**Re: Rapiscan AIT System Radiation Survey Reporting**

**R-0646-1 Addendum  
(Documentation Errors)**

Product Name	Secure 1000SP (Single Pose)
Serial Number	<b>S51009003</b>
Radiation Emission Measurement	Radiation Survey Dated: 06/15/2010
RSO Initials

<b>Rapiscan</b> S Y S I O M S	<b>Secure 1000 Radiation Emission Measurement</b>	FORM R-0646-1 (Single Pose)
----------------------------------	---	--------------------------------

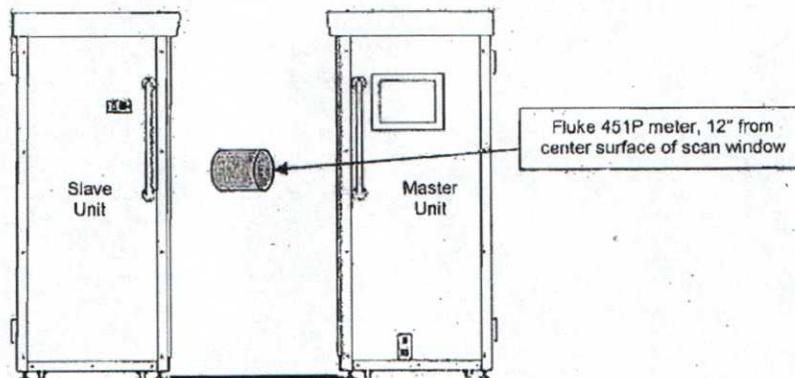
No value indicated for background radiation. Typical values range from 7uRem/hr to 13uRem/hr at sea level. Note: Absence of value has no adverse impact on calculations.

The service technician should attend refresher training.

The corrected data indicates this system was operating within expected parameters. No re-survey is required for this system.
